FCO CA07202: Picker down sensor bracket

Document number: 719-00535A-C-PR01

- Trendsetter® AL
- Trendsetter NEWS (except NEWS SA)

Figure 1: Picker down sensor mounting bracket on picker rail (viewed from center of load table)

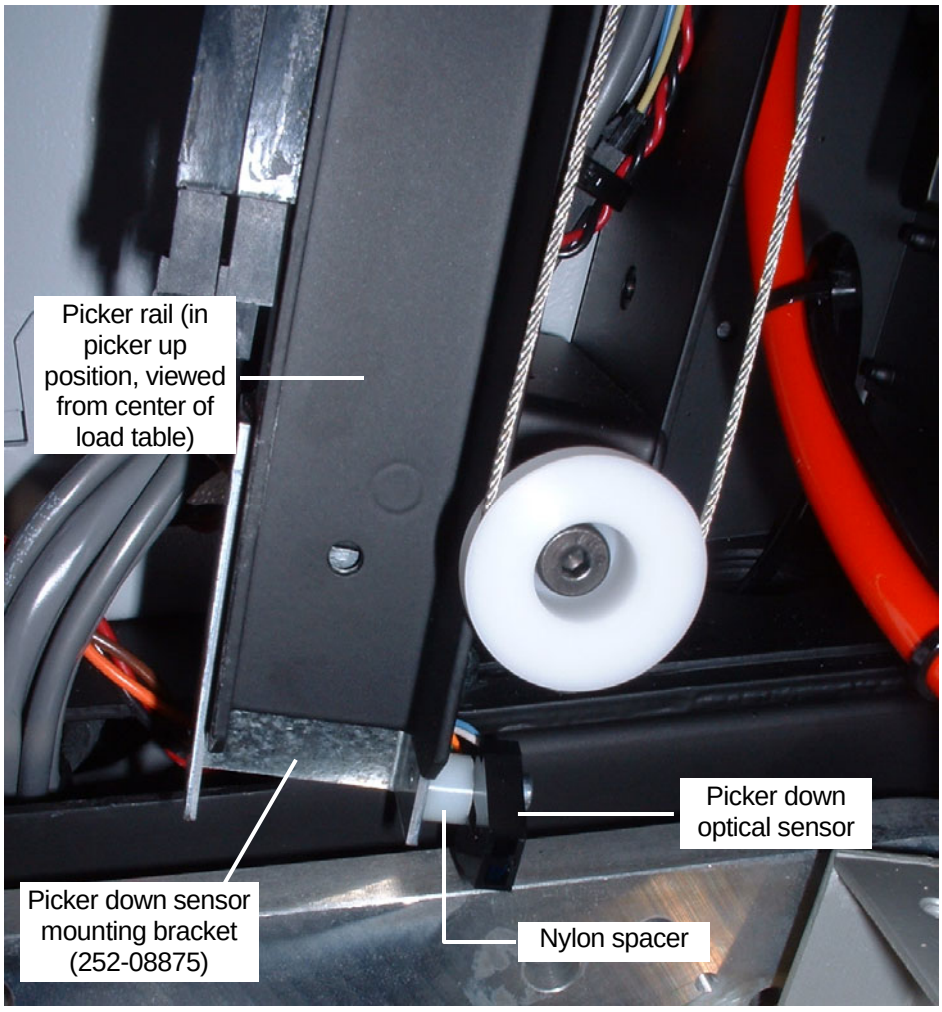
The foam tape used to block the picker down sensor signal causes intermittent sensing problems.

Move the sensor to a lower position using the bracket in kit #512-00288A. This bracket repositions the picker down sensor so that it is blocked by solid metal, not the foam tape, which results in more reliable operation.

1. Remove the panel on the left side of the load table.
2. Remove the picker down optical sensor.
3. Remove the foam tape used to block the picker down sensor signal.
4. Attach the optical sensor to the new mounting bracket. Use the Nylon spacer between the bracket and the sensor.
5. Carefully mark the position of the bottom of the picker rail so that you can re-install it in the same position without affecting the operation of the picker.
6. Remove the bolt and Nylon nut that hold the bottom of the picker rail.
7. Place the new bracket over the bottom of the picker rail. (See Figure 1.)
